MANDATORY SERVICE BULLETIN Z 242/21a

1. MODELS AFFECTED: All Z 242L aircraft up to S/N 0696 inc. and from S/N 0700 up to 0703 inc.
2. SUBJECT: Occurance of the elevator fairings damage in operation.
3. CORRECTION:
 - 3.1 Modify the elevator.
 - 3.2 Enter the procedures for execution of the tail slides into the Flight Manual. On this occasion the Manufacturer has carried out any other small modifications of the Flight Manual.
4. TIME OF COMPLIANCE: Correction 3.1:
In case of the elevator damaged - simultaneously with its repair; otherwise at the nearest 100-hour Inspection.

obrázek 1
figure 1

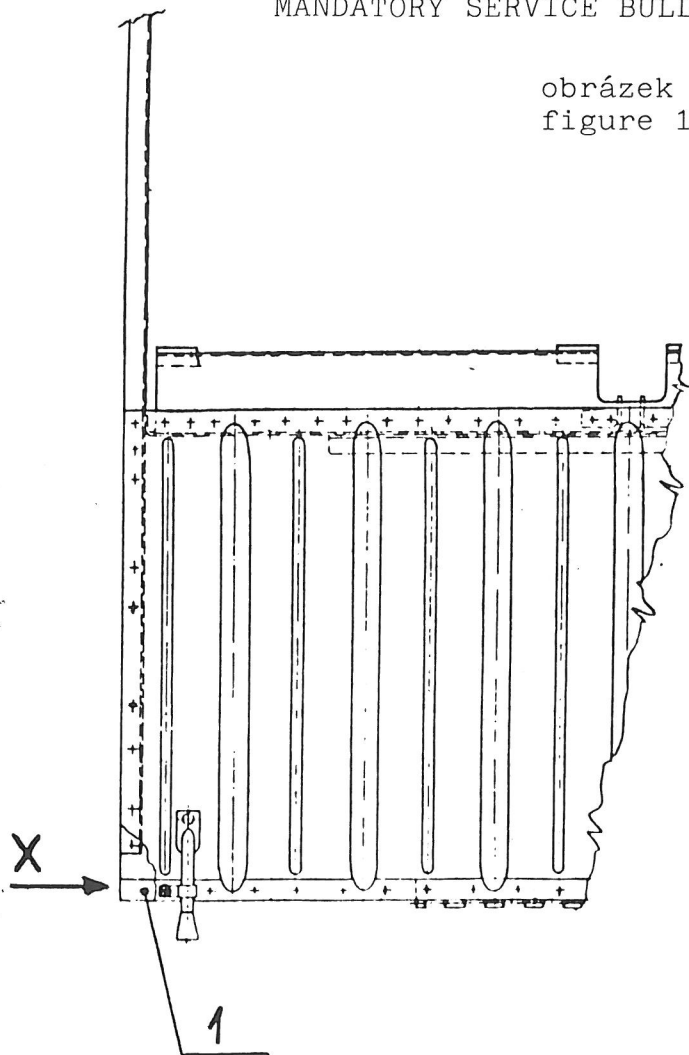
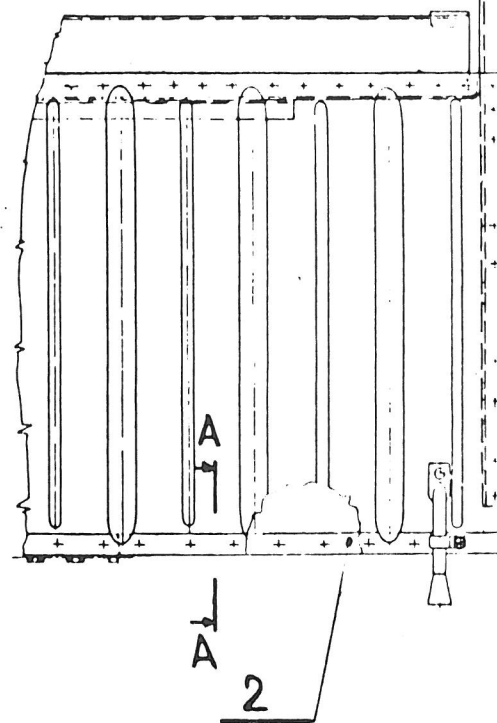
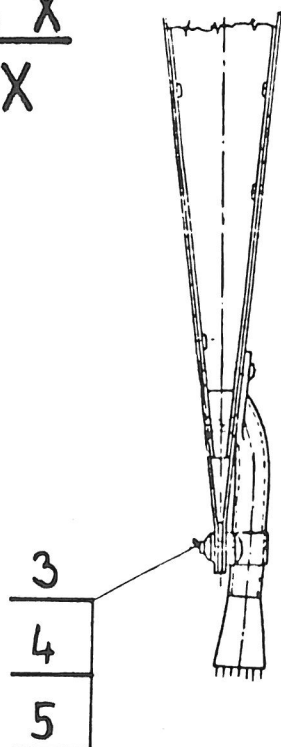
Correction 3.2:
Immediately after this Bulletin receipt.
5. CORRECTION PERFORMED BY: The Aircraft Operator; the works connected with the Correction 3.1 will performed by the Authorized organization.
6. EXPENSES COVERED BY: The material and the parts necessary for the elevator modification - the Aircraft Manufacturer;
the work including the paint renewal - the Aircraft Operator.
7. PROCEDURE:
 - 7.1 a) Remove the tip arches.
 - b) According to the Enclosure Fig.No. 1 drill off the rivets in the trailing edge up to the piano-hinge of the trim tab and the balance tab from the elevator L.H. side as well as R.H. side.
Dismount screws (Item 3), nuts (Item 4) and washers (Item 5) at the dischargers and remove the trailing-edge stiffening pieces (Item 1 and 2).

obrázek 2
figure 2

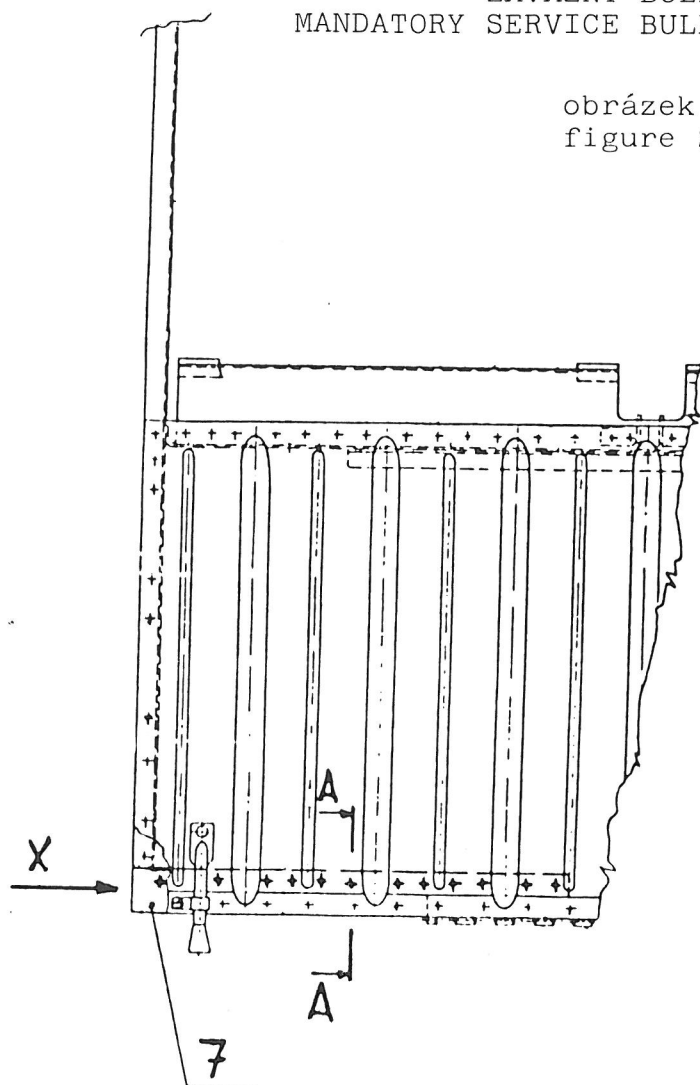
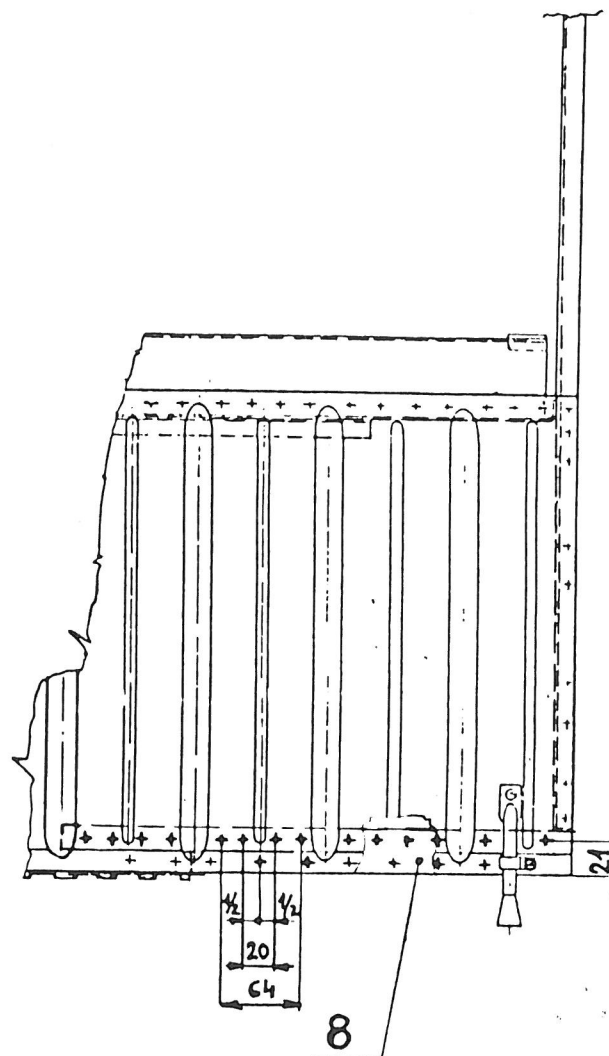
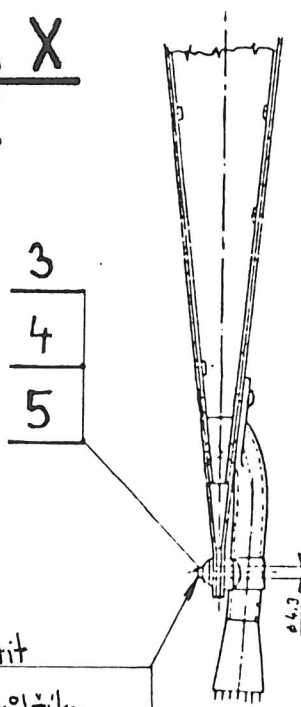
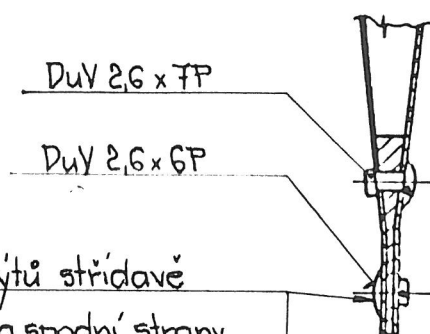
c) According to the Enclosure Fig.No.2 insert the stiffener L.H. (Item 7) and the stiffener R.H. (Item 8) into the elevator trailing edge from the elevator L.H. side as well as from the elevator R.H. side, drill the holes for rivets and rivet them on. Drill the holes for screws of dischargers and re-mount screws (Item 3), nuts (Item 4) and washers (Item 5).

Matici poz. 4 pojistit
po obvodě třemi důlčiky
Lock the nut (Item 4) on the
periphery with three centre punches

Hlavy nýtů střídavě
z horní a spodní strany
Rivet heads staggered
from the top as well as
from the bottom side
